JOCPROJ- EDINBURG CONCESSION 2025 Addendum #1

South Texas ISD Concession Storage Building – Edinburg Texas

ADDENDUM NO. 1

A4.01

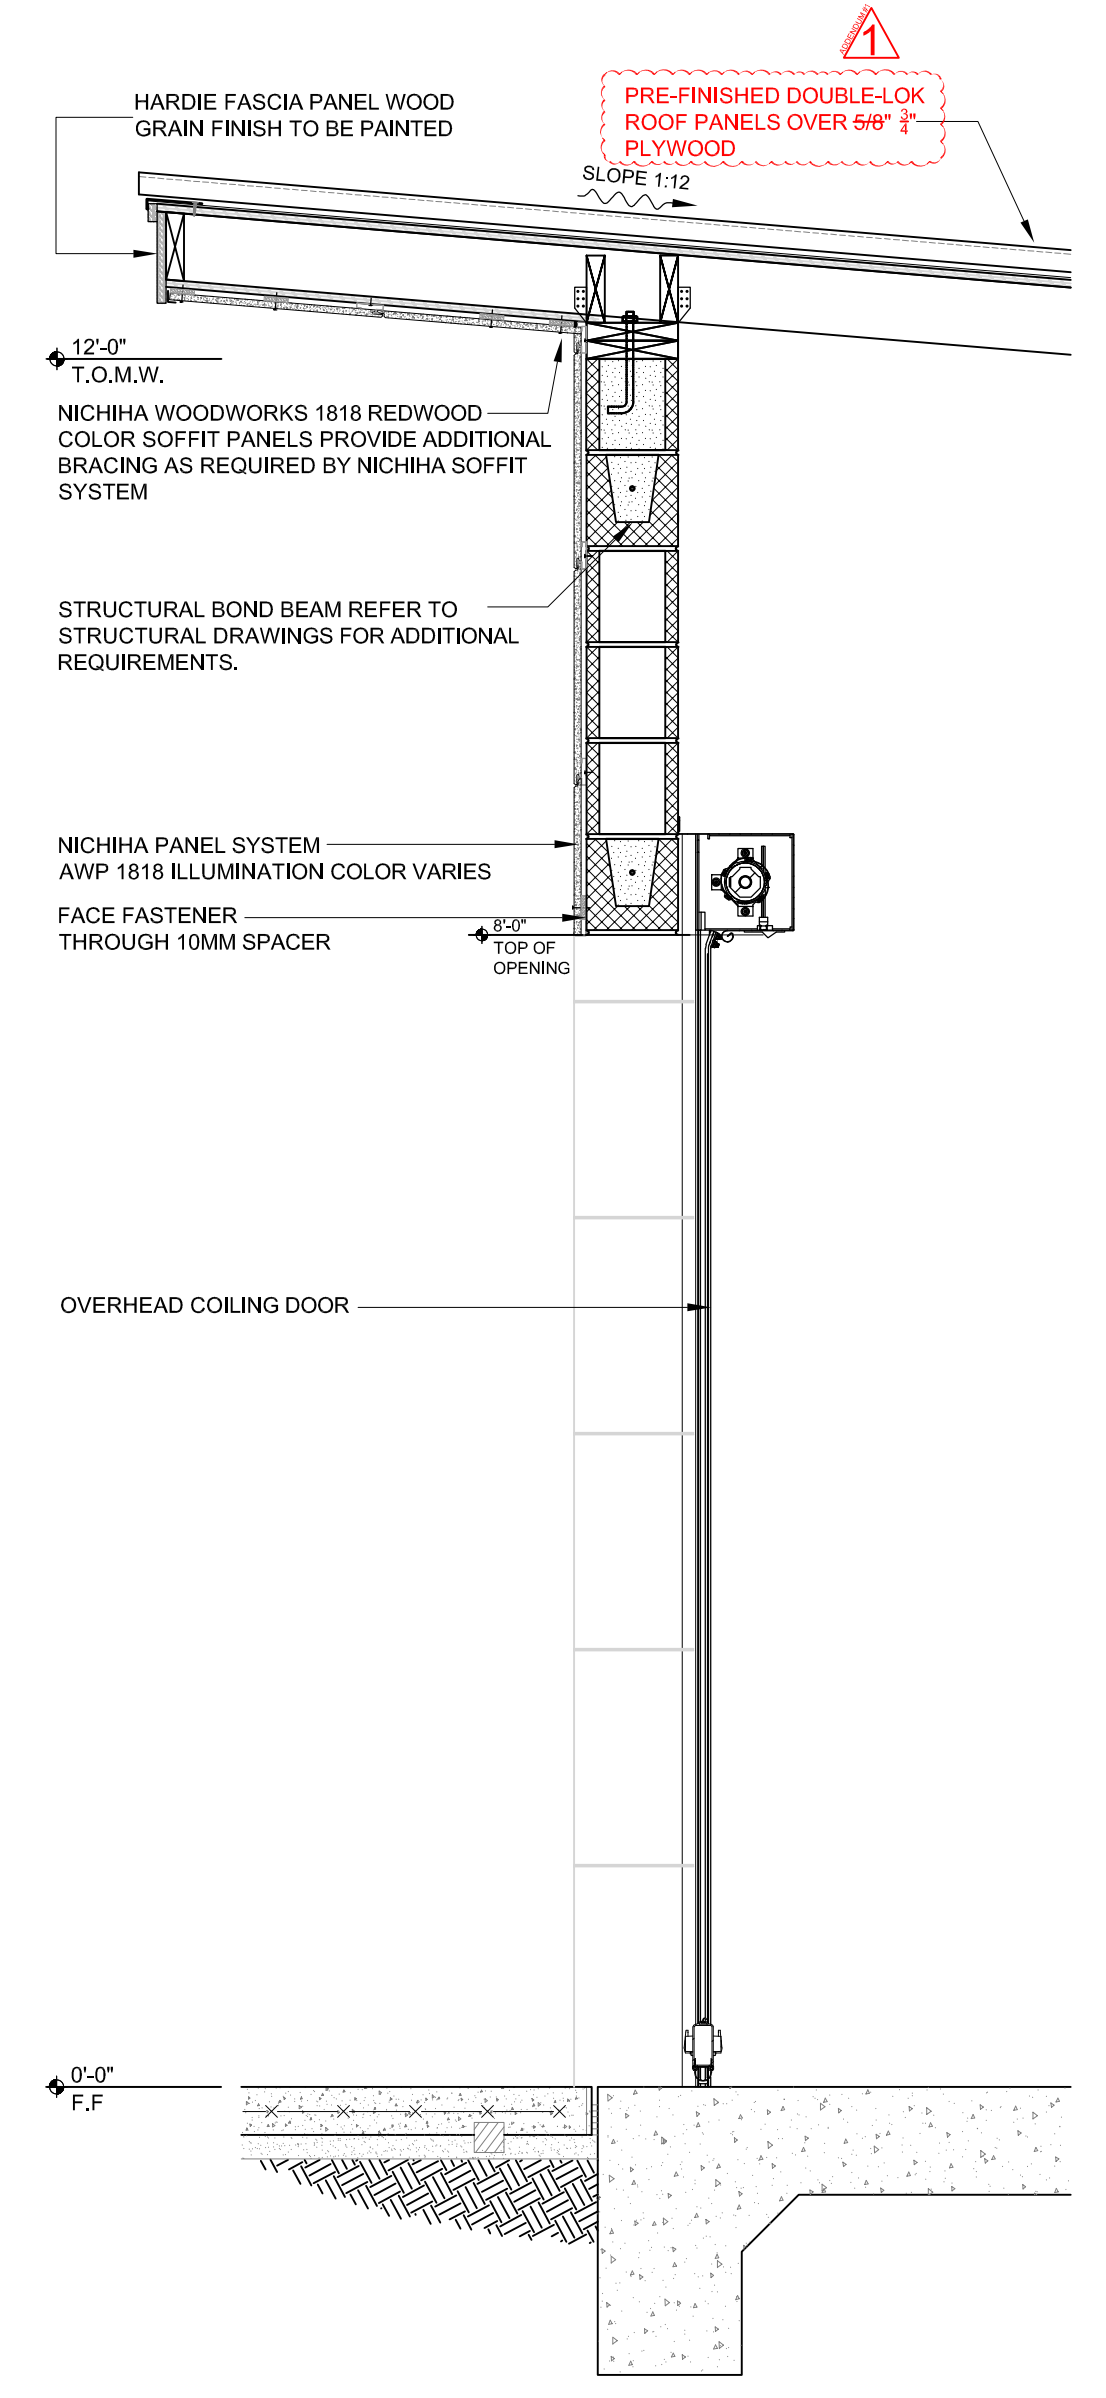
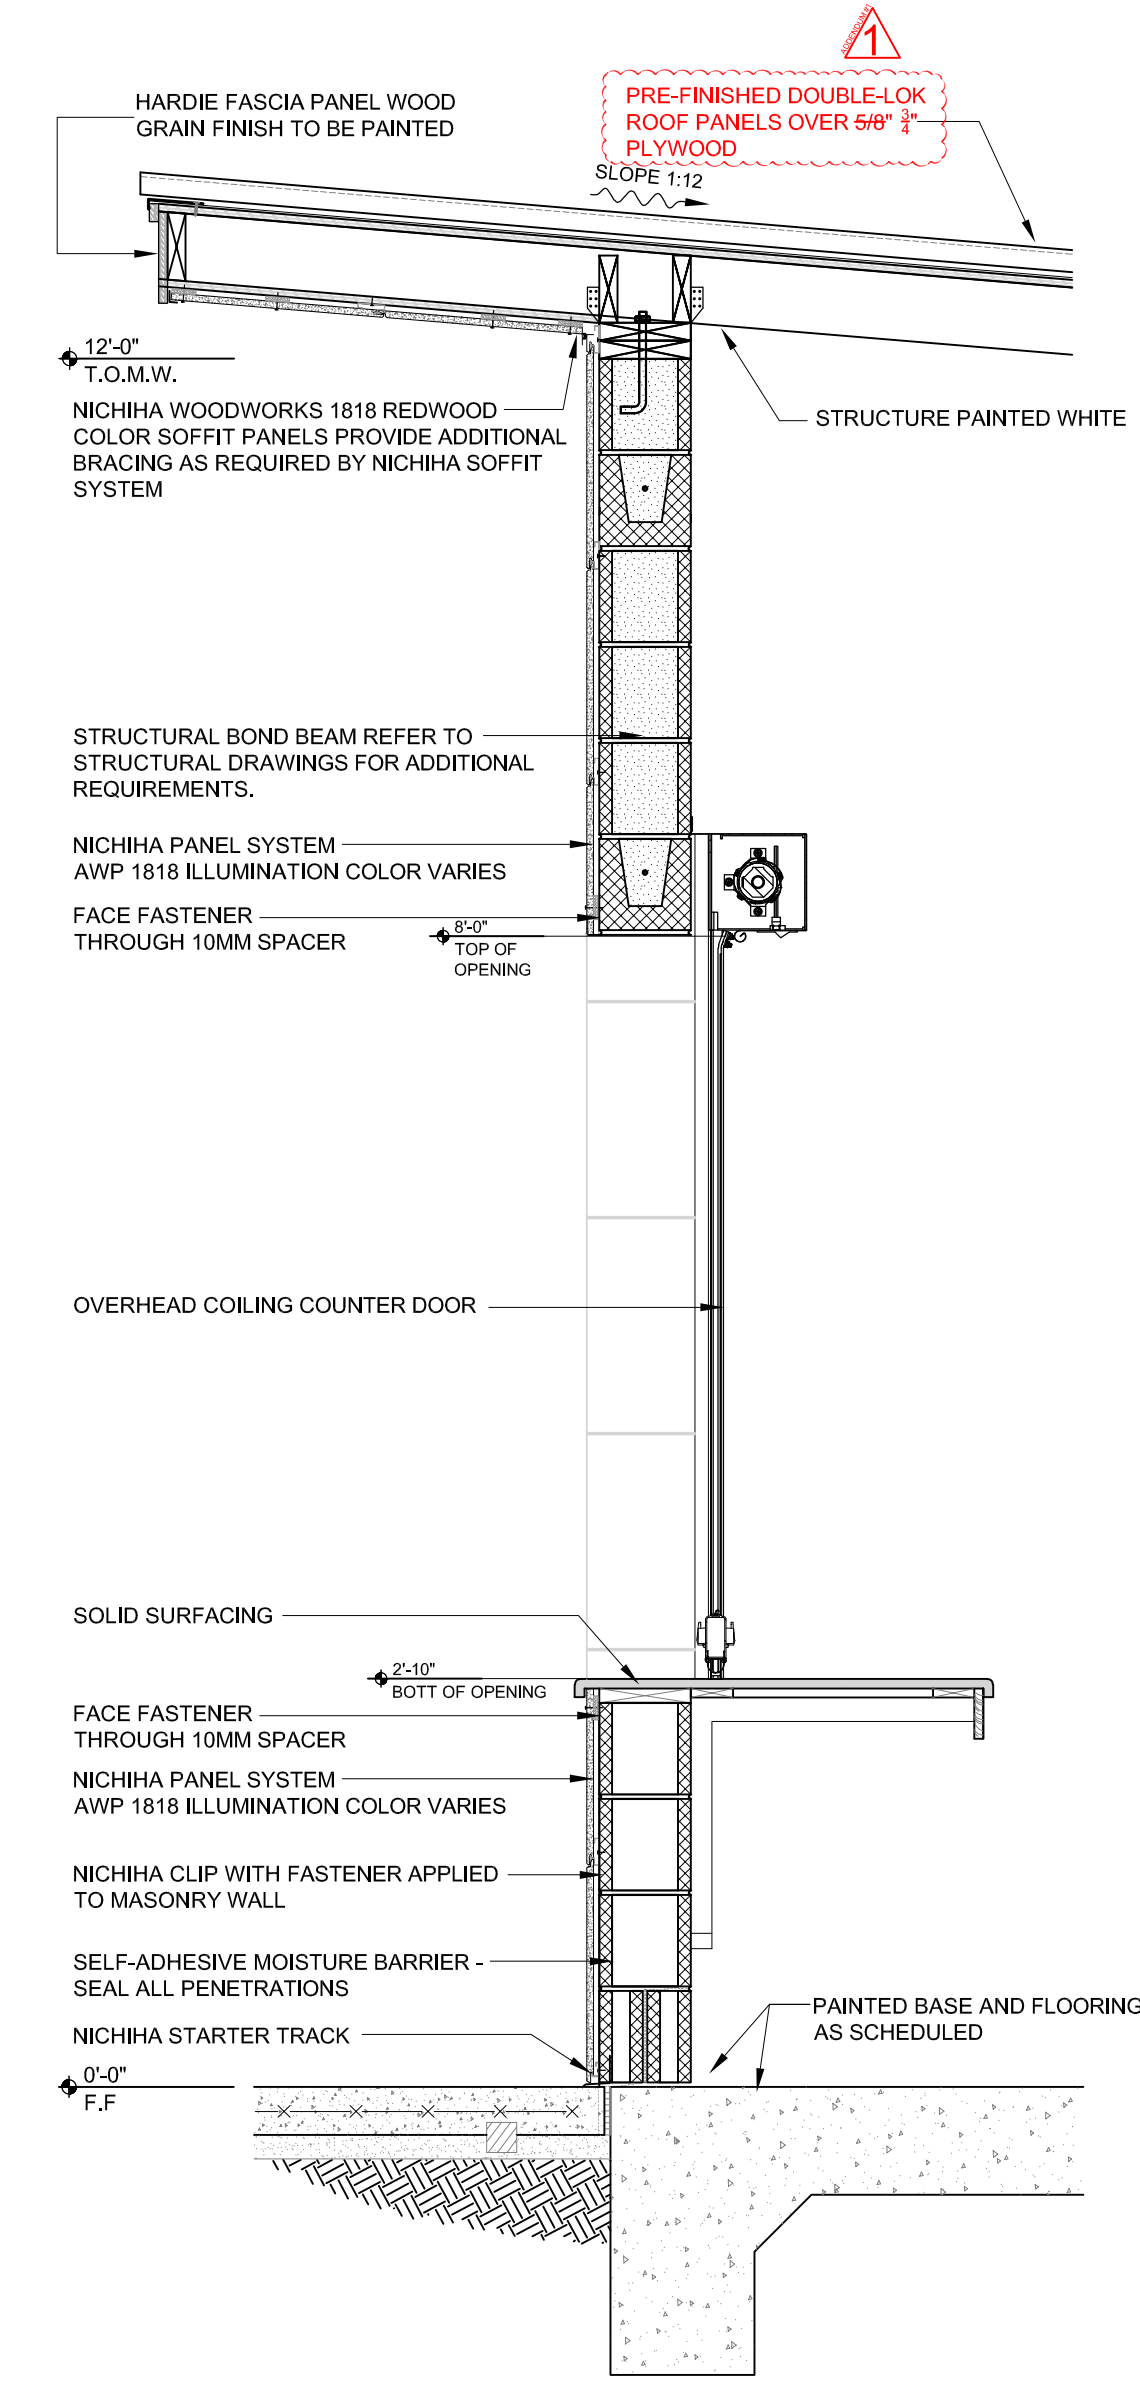
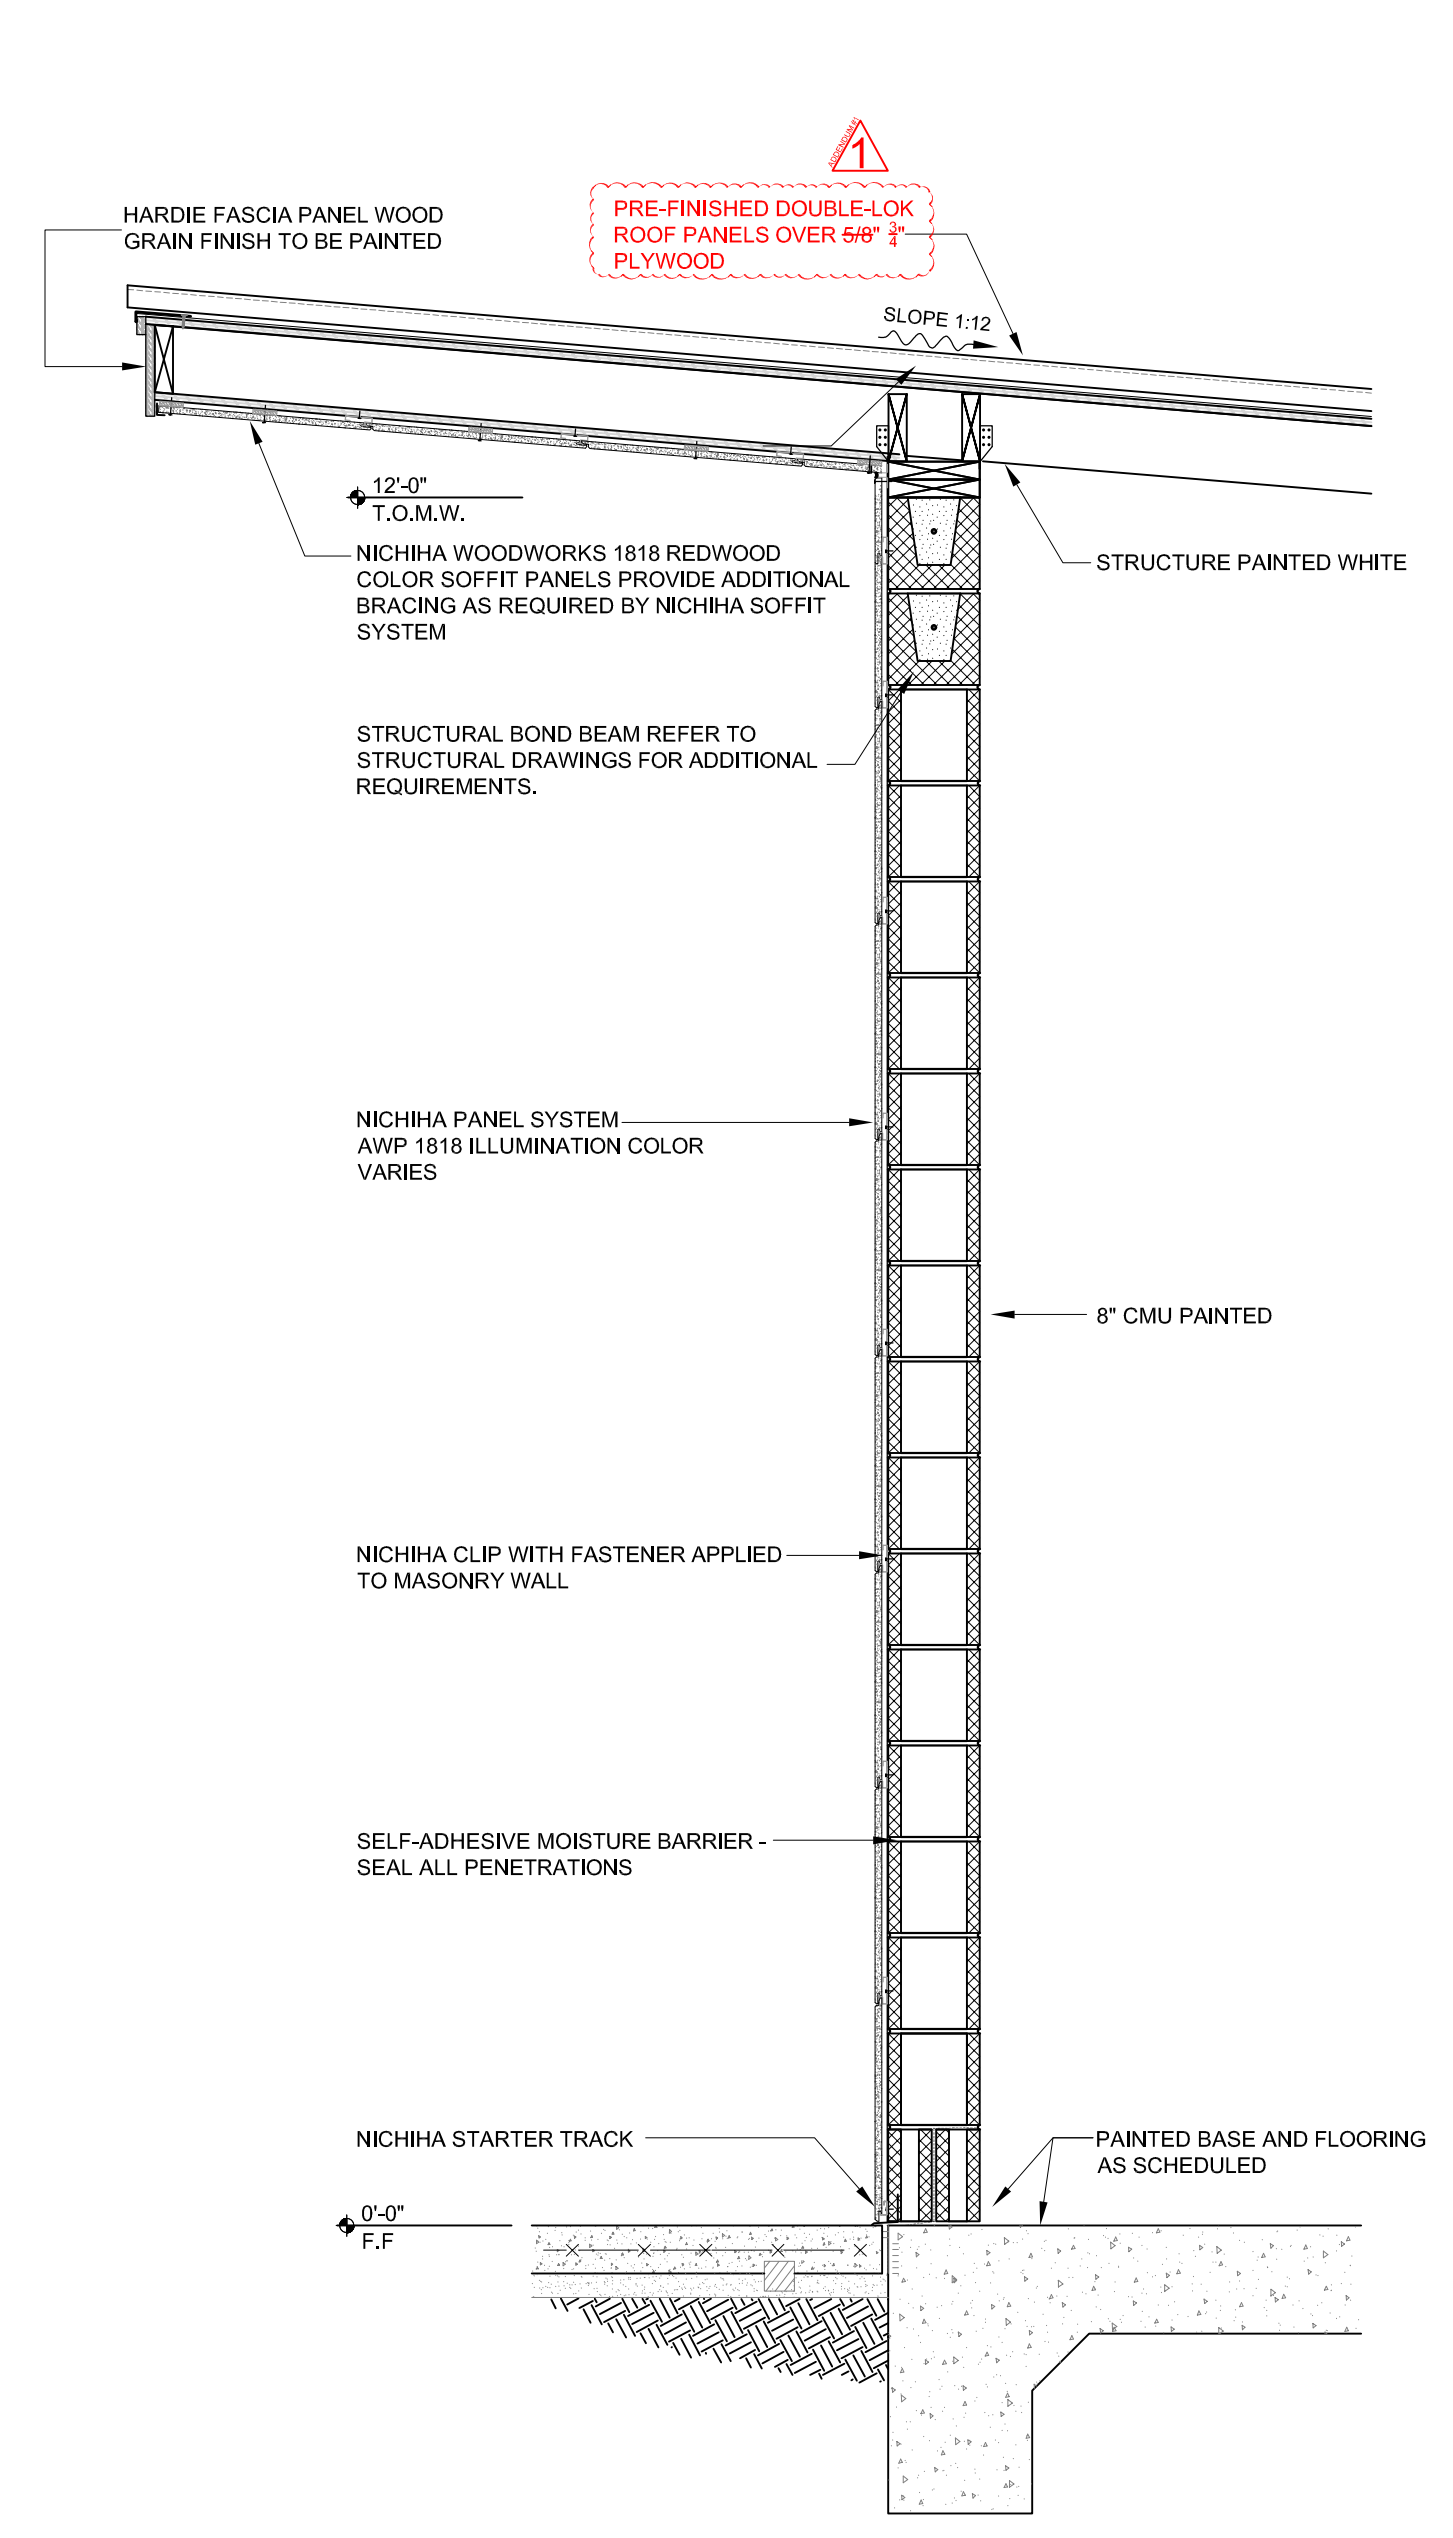
1. A4.01
 - a. Wood sheathing shall be ¾" thick in lieu of 5/8" to match Sheet S1.0
2. Sheet S1.2
 - a. Minimum Depth of excavation shall be 3'-0" in lieu of 4'-0" previously shown
3. P2.01 General Notes
 - a. Delete general note 5

REVISION NOTE TO READ SHEATHING IN LIEU OF 8" SHEATHING
